**Addendum No. 1**

**August 28, 2025**

**City Project No.: 23-069**  
**Roads Program Capital Improvement Project**

**IMPROVEMENTS PLAN - FLORENCE STREET I**

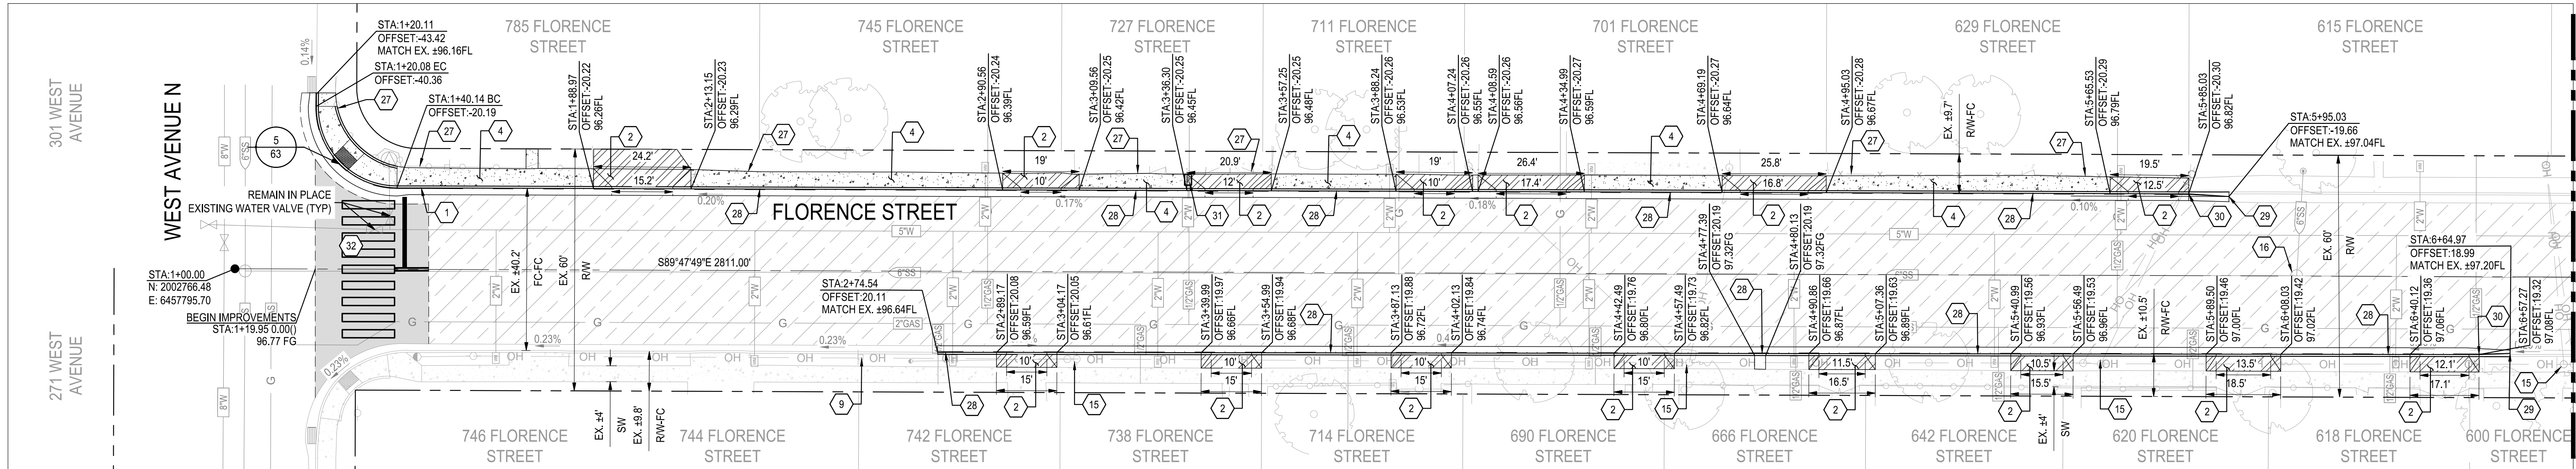
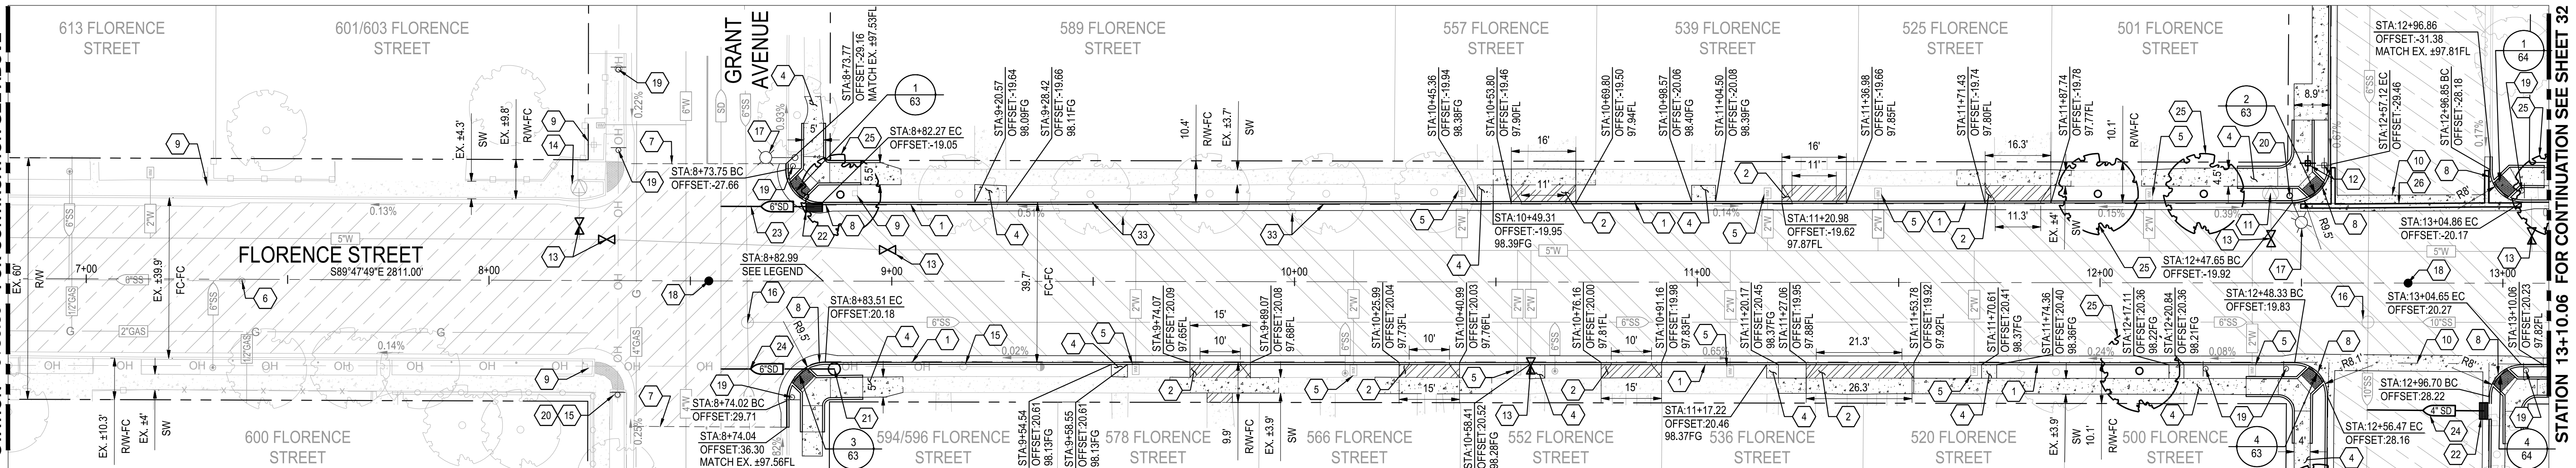
Sheet 31, Keynote #11: ~~REMOVE AND REPLACE FIRE HYDRANT PER CITY OF TURLOCK STD. W-1.~~ **EXISTING FIRE HYDRANT TO REMAIN IN PLACE.** (THIS FIRE HYDRANT WAS RELOCATED WITH ANOTHER PROJECT.

Q1: Under what bid item is the following work paid under, remove and replace fire hydrant per City of Turlock STD. W-1 called out on drawing no. 31 under keynote 11?

A1: Bid Item schedule #59, ~~Reset Fire Hydrant to Grade~~ has been revised to ***Remove and Replace Fire Hydrant***, and the quantity has been revised from 2 to ***1***.

**IMPROVEMENTS PLAN - FLORENCE STREET II**

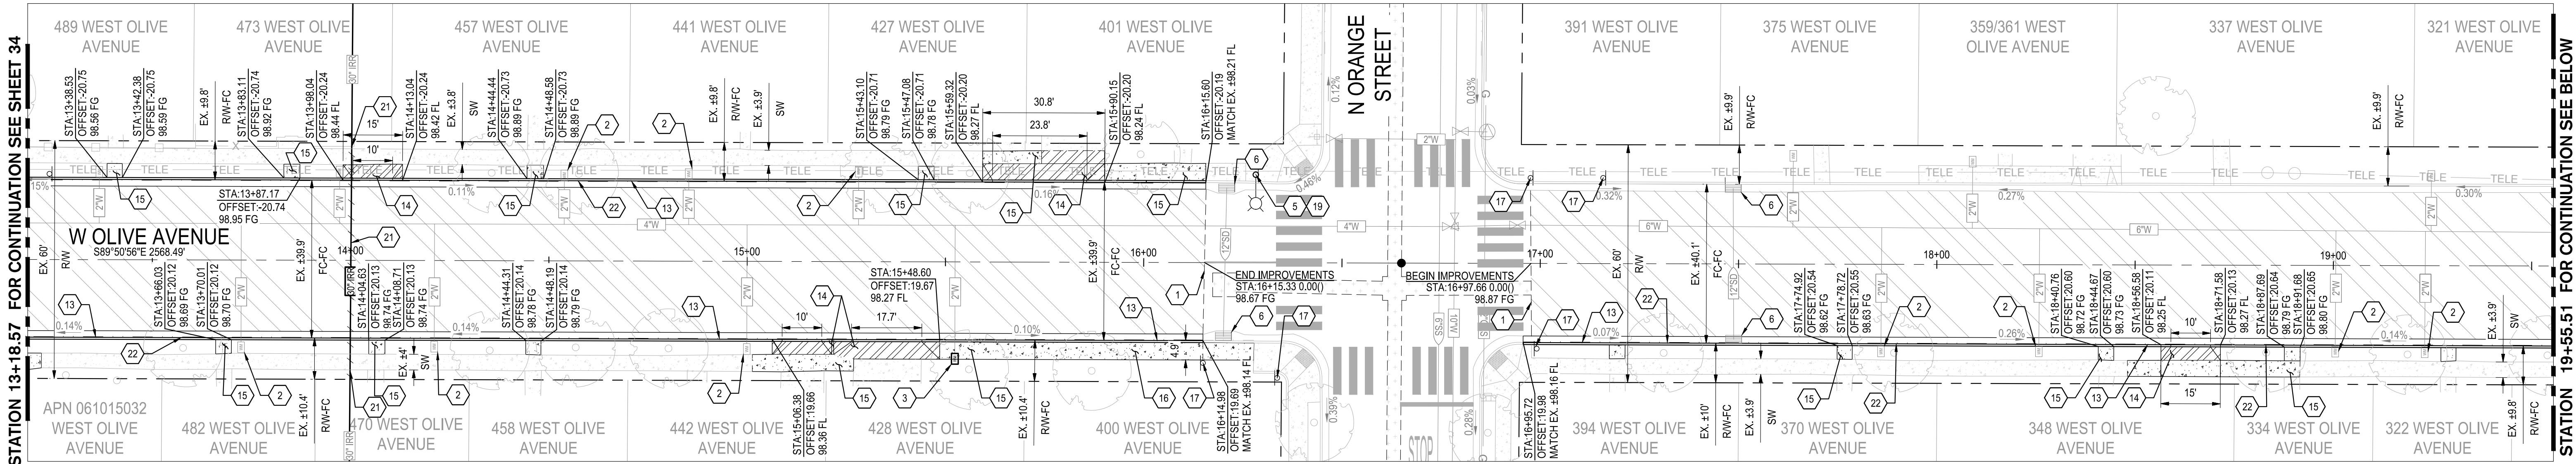
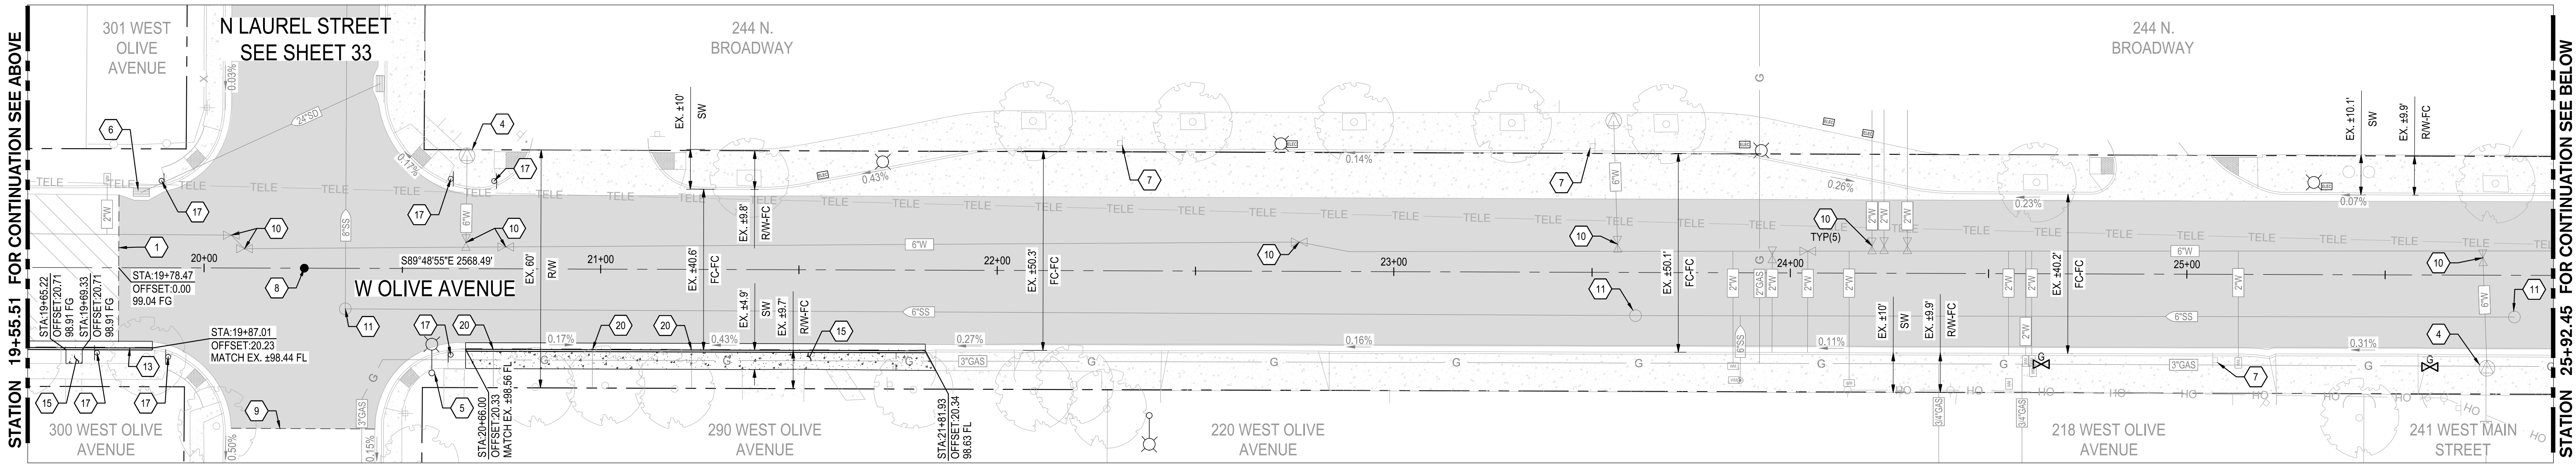
Sheet 32, Keynote #19: Construction Keynote 19 on sheet 32 has been revised from Construction Keynote 19 to 18.

Q20: Sheet 32, station 14+00 has the removal and disposal of 60LF of 30" pour in place irrigation pipe. There is a callout for note 19 referencing the 30" pour in place irrigation pipe, but no note 19 on sheet 32. Please clarify if there should be a note 19 or no note.

A20: Construction Keynote 19 on sheet 32 has been revised to Construction Keynote 18.

IMPROVEMENTS PLAN - ANGELUS STREET I

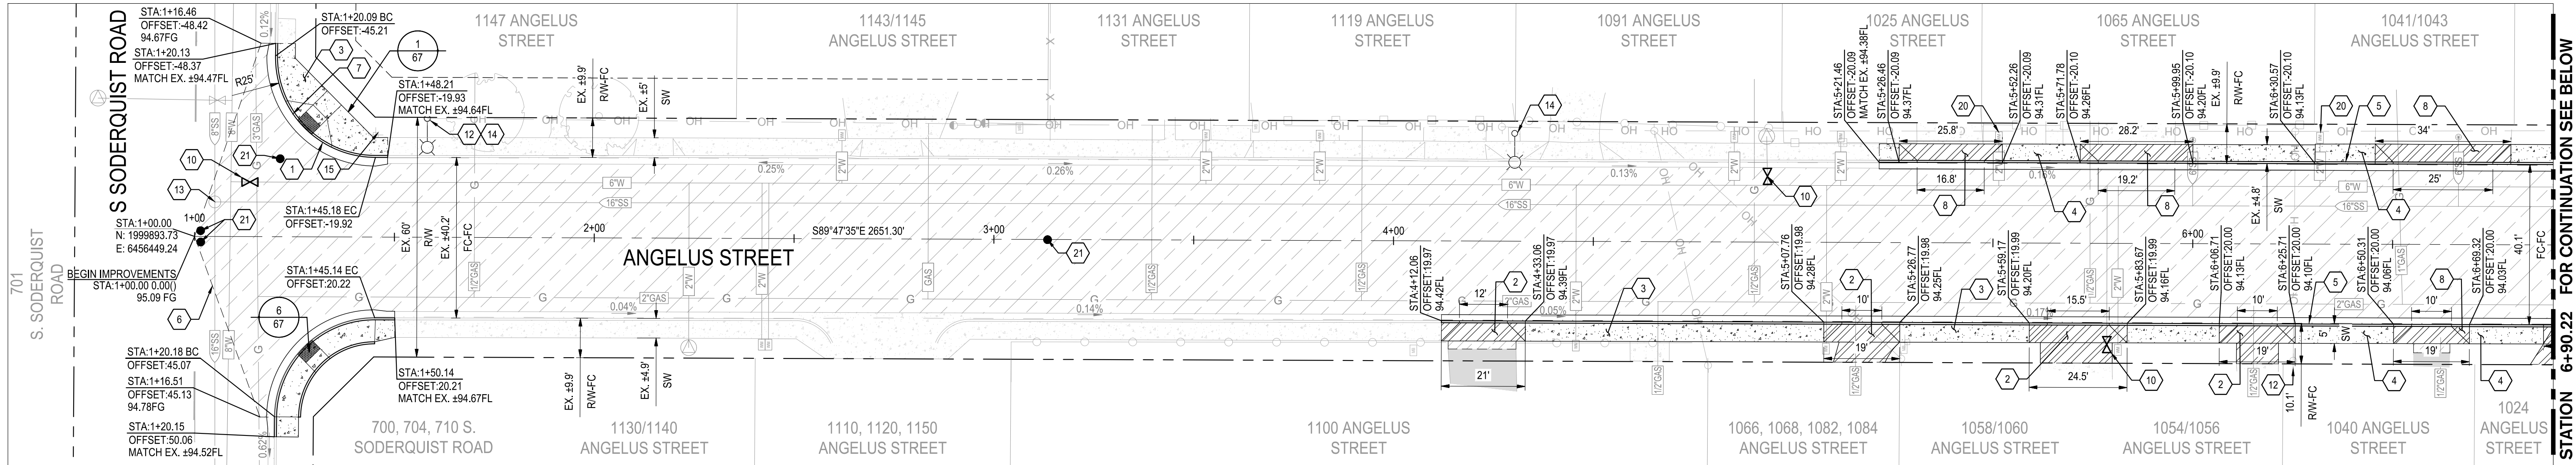
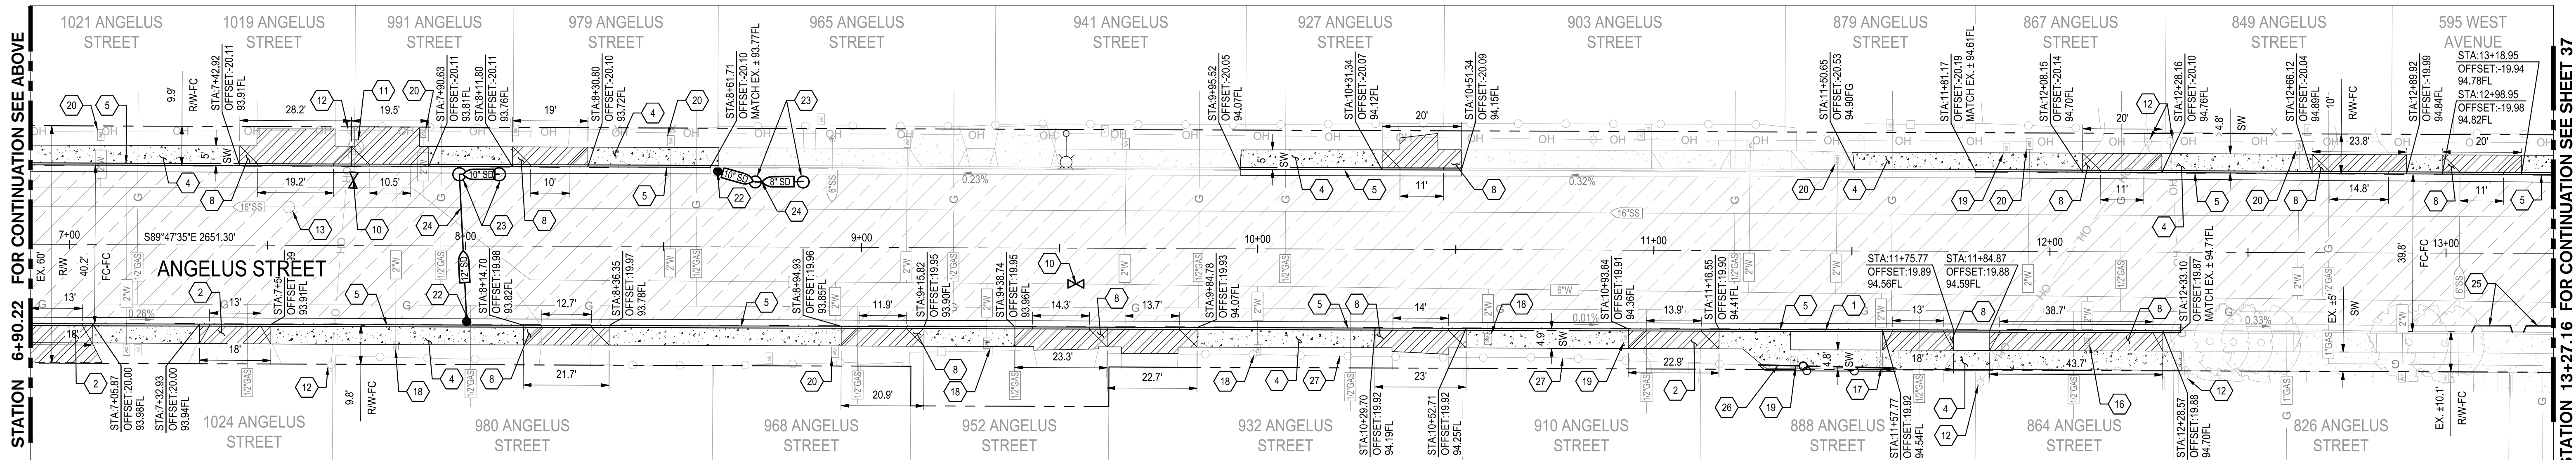
Sheet 35, Keynote #20: ~~RECONNECT DOWNSPOUT DRAINPIPE.~~  
**REINSTALL SIDEWALK UNDERDRAIN PER CITY OF TURLOCK STD. SD-7.**

Sheet 35, The Pavement Legend, Trench Excavation, was revised to: STORM DRAIN TRENCH EXCAVATION AND BACKFILL PER CITY OF TURLOCK DETAIL T-1, **T-2, & MODIFIED T-3.**

IMPROVEMENTS PLAN - N BEECH STREET I

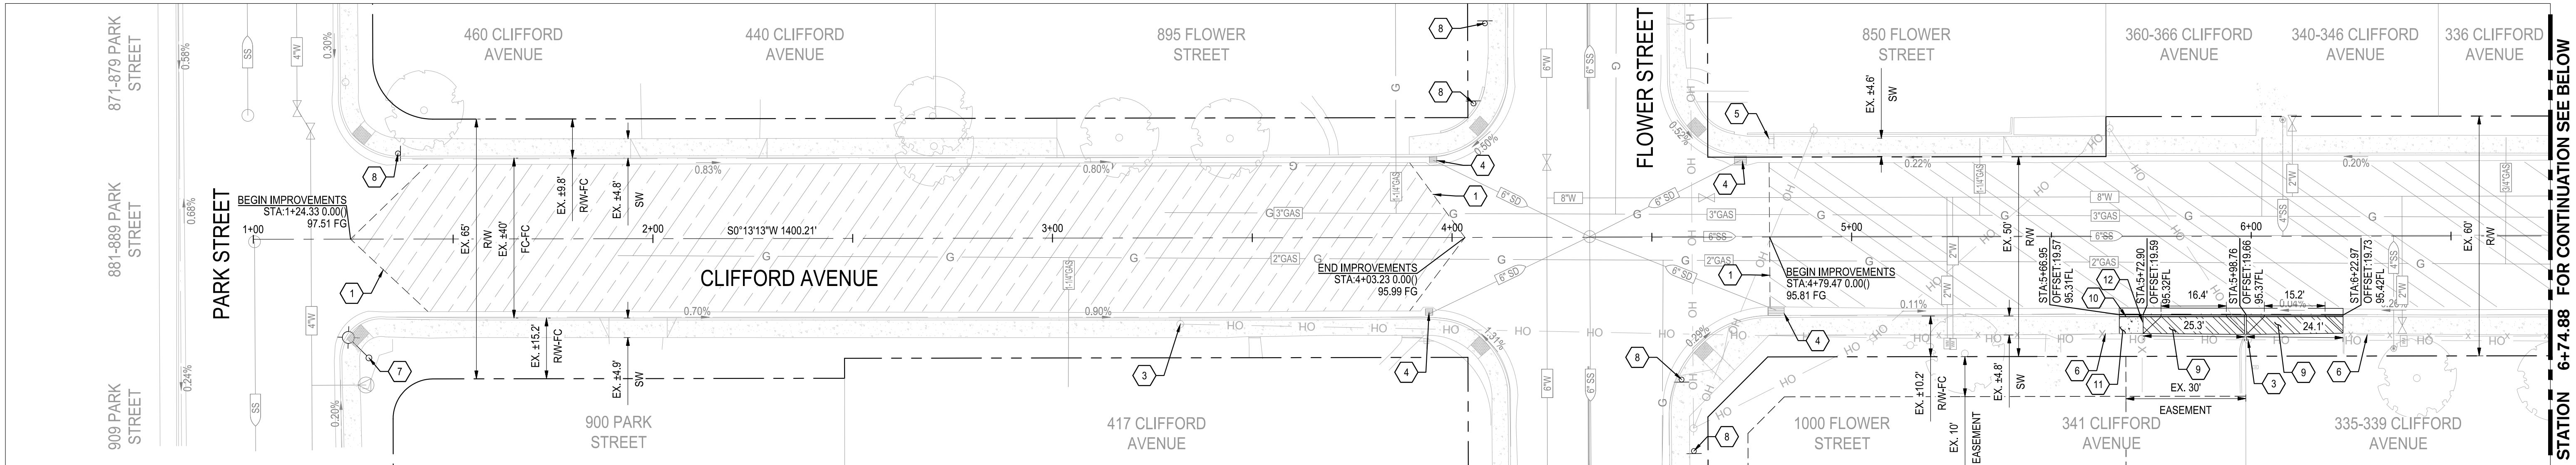
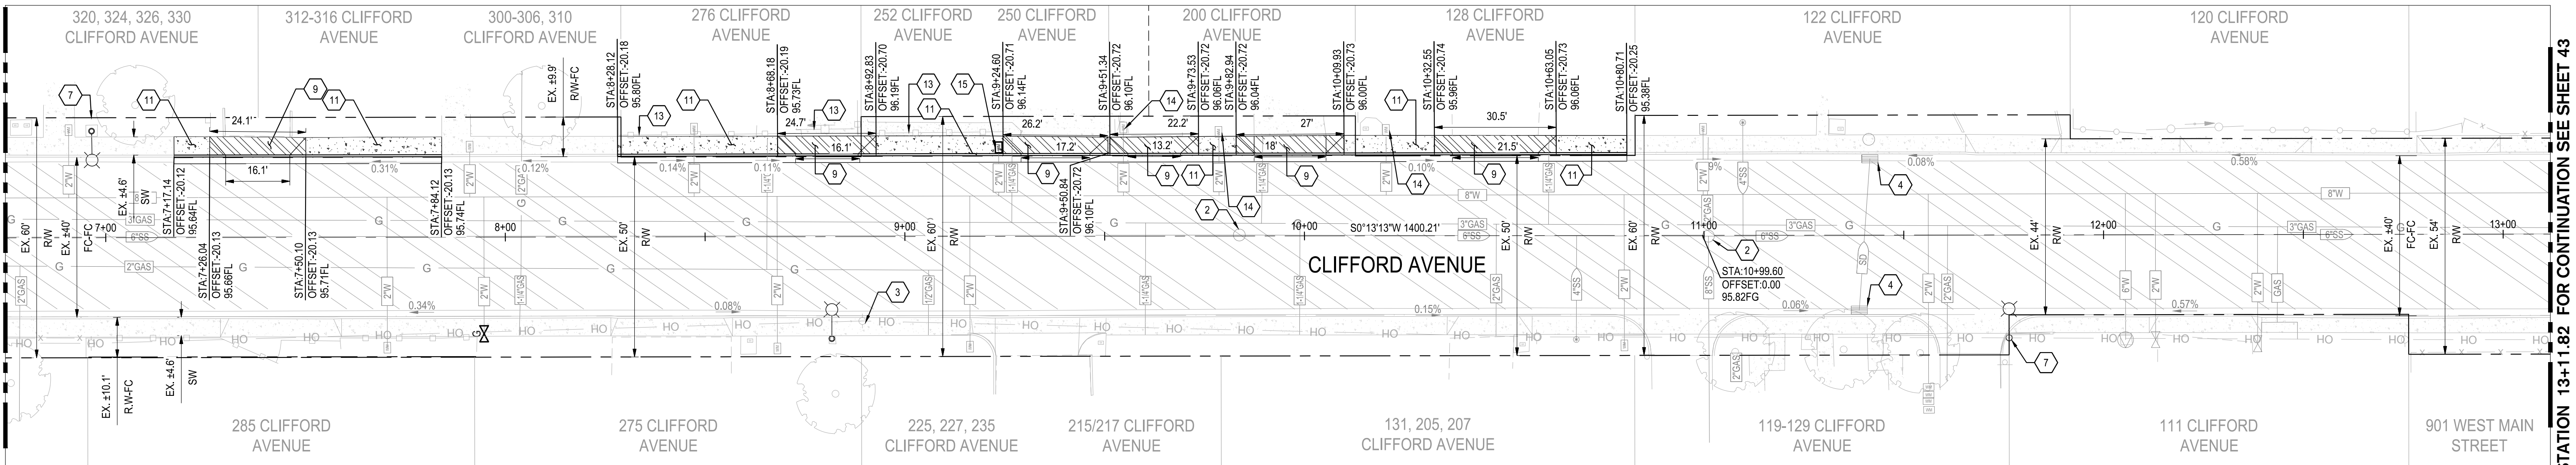
Sheet 40, Keynote #13: REMOVE AND DISPOSE EXISTING STORM DRAIN UNDER DRAIN  
**TINHORN.**

Sheet 40, Pavement Legend: Add Trench Excavation hatch to legend. **TRENCH EXCAVATION STORM DRAIN TRENCH EXCAVATION AND BACKFILL PER CITY OF TURLOCK DETAIL T-1, T-2, & MODIFIED T-3.**

Q5: Under what bid item is the following work paid under, remove and dispose of existing storm drain under drain called out on drawing no. 40 under keynote 13?

Q24: Bid Schedule shows 2 EA Reset Fire Hydrant to Grade for Bid Item # 59. The plans, on sheet 40, only show one fire hydrant to reset per city of Turlock per detail STD. W-1. Please confirm the quantity.

A5: Sheet 40, Keynote #13 has been revised to: REMOVE AND DISPOSE EXISTING STORM DRAIN UNDER DRAIN ***TINHORN.***

A24: Bid Item schedule #59, ~~Reset Fire Hydrant to Grade~~ has been revised to **Remove and Replace Fire Hydrant**, and the quantity has been revised from **2** to **1**.

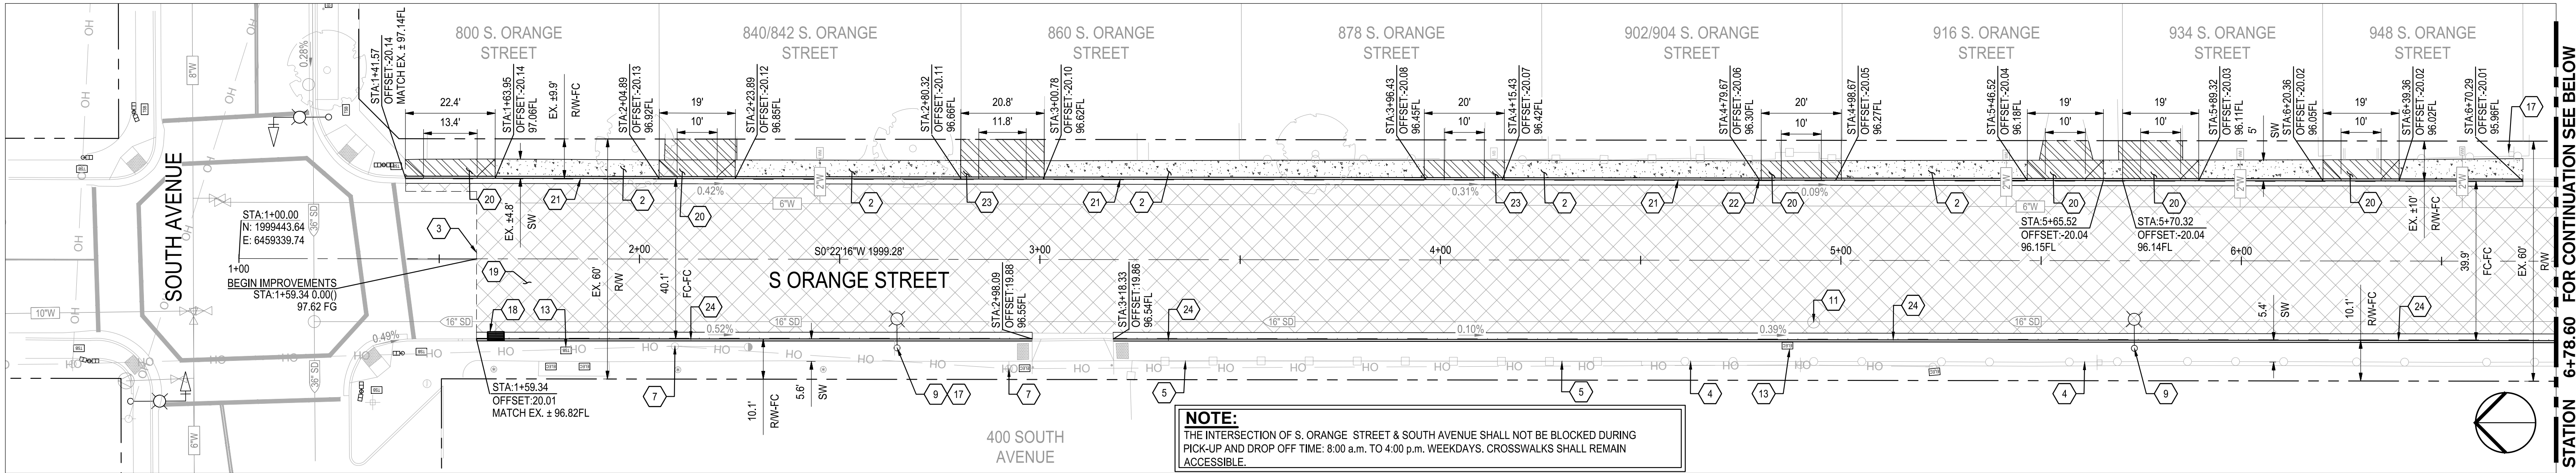
Sheet 42, Keynote #12: ~~RECONNECT DOWNSPOUT DRAINPIPE.~~  
**REINSTALL SIDEWALK UNDERDRAIN PER CITY OF TURLOCK STD. SD-7.**

Q6: Under what bid item is the following work paid under, reconnect downspout drainpipe called out on drawing no. 42 under keynote 12? Can you also provide a detail for this work?

A6: Sheet 42, Keynote #12 has been revised to: ~~RECONNECT DOWNSPOUT DRAIN PIPE.~~ ***REINSTALL SIDEWALK UNDERDRAIN PER CITY OF TURLOCK STD. SD-7.***
